City of Detroit
Inter-Departmental Communication

RE: Petition No. 931 Revised
Request to Outright Vacate Dumfries and Various Alleys and Conversion to Easement of Bayside Ave. in the Area Bound by Oakwood Blvd., Sanders, Dunkirk, and the Wabash Rail Road

RE: Petition No. 931
Request to Outright Vacate a Portion of Bayside and Dumfries and Various
Alleys in the Blocks Bound by Oakwood Blvd., Sanders, Dunkirk, And Wabash
Rail Road

CITY OF DETROIT	
CITY ENGINEERING DEPARTMENT	
SURVEY BUREAU	
JOB NO.	01-01
DRWG. NO.	X 931

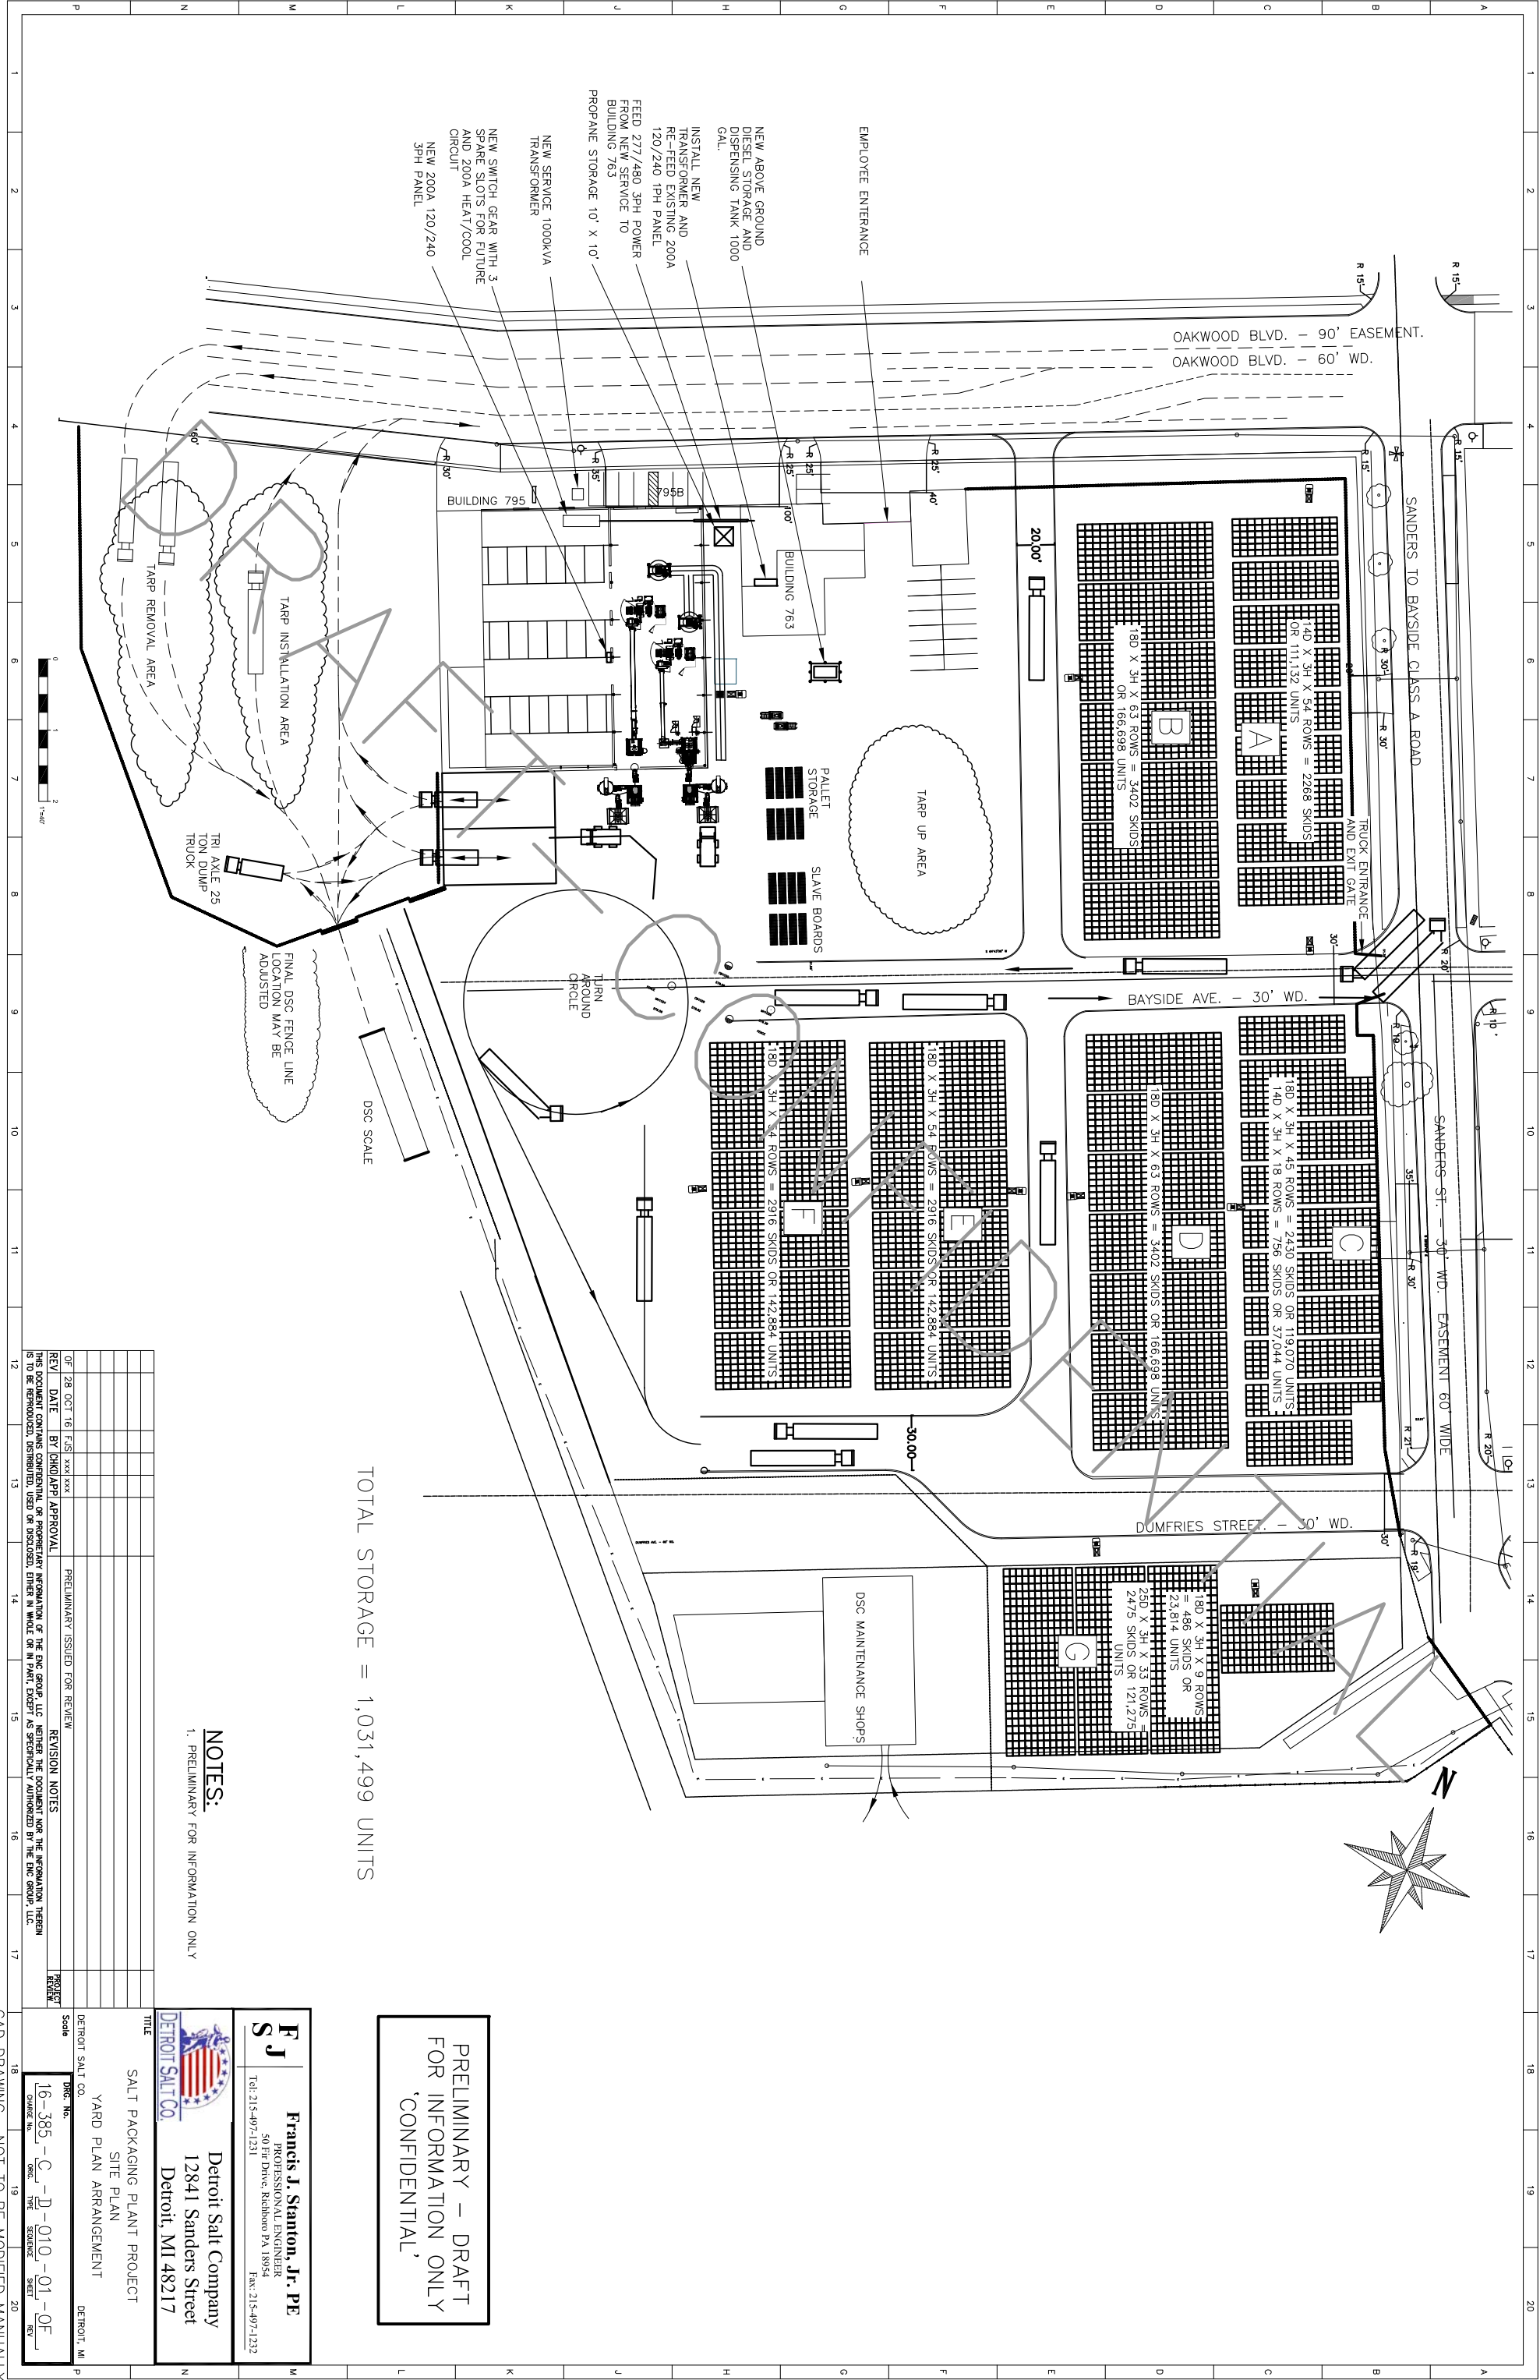
- Our records indicate that there is a large sewer and a water main in Bayside St. DWSD has no objection to the requested conversion to easement for the full width of Bayside Ave., 60 feet, provided that the attached Provisions for Conversion to Easement are strictly followed.
- There is a water main in Dumfries Ave. DWSD has no objection to the requested outright vacation provided that the attached Provisions for Outright Vacation are strictly followed.
- There are sewers in the alleys between Oakwood Blvd. and Bayside Ave., and between Bayside Ave. and Dumfries Ave. DWSD has no objection to the requested outright vacation provided that the attached Provisions for Outright Vacation are strictly followed.

CITY OF DETROIT CITY ENGINEERING DEPARTMENT SURVEY BUREAU	
JOB NO.	01-01
DRWG. NO.	X 931

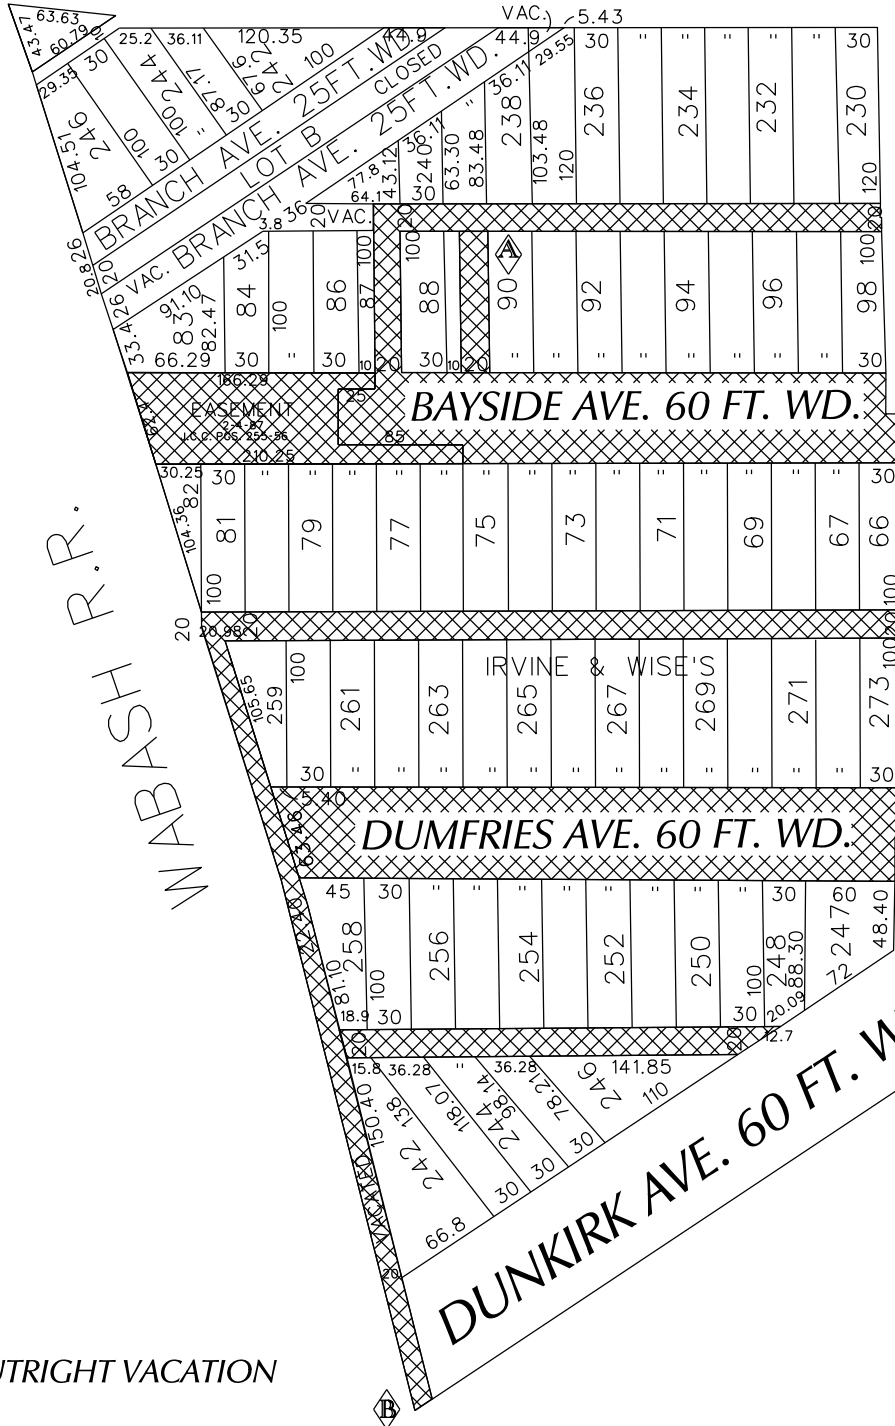
- Our records indicate that there are sewers and water mains in the areas of vacation. DWSD, objects to the outright vacations. However, DWSD has no objections if the petitioner agrees to relocate the sewers and water mains in accordance with the attached Provisions for Relocation at no cost to DWSD.
